Proposals for amendments to annexes A and B of ADR:

Section 9.7.6 – Rear protection of vehicles

Transmitted by the Government of France*

| Executive summary: | The proposal aims to clarify the requirements of 9.7.6 in respect of the distance of at least 100 mm between the rear wall of the tank and the rear of the bumper, as well as of tilting shells, to avoid problems of interpretation. |

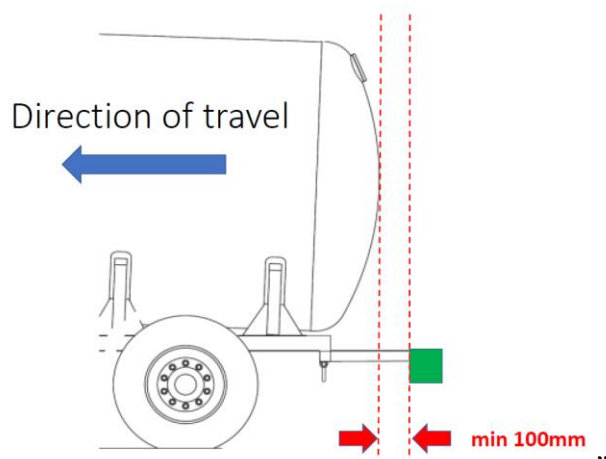
10. Amend the first two sentences of 9.7.6 to read as follows:

“A bumper sufficiently resistant to rear impact shall be fitted over the full width of the tank at the rear of the tank-vehicle. There shall be a clearance of at least 100 mm between the rear of the tank (or of its projecting fittings in contact with the substance being carried) and the face of the bumper facing the rear wall of the tank. This clearance shall be measured as specified in the figure below:
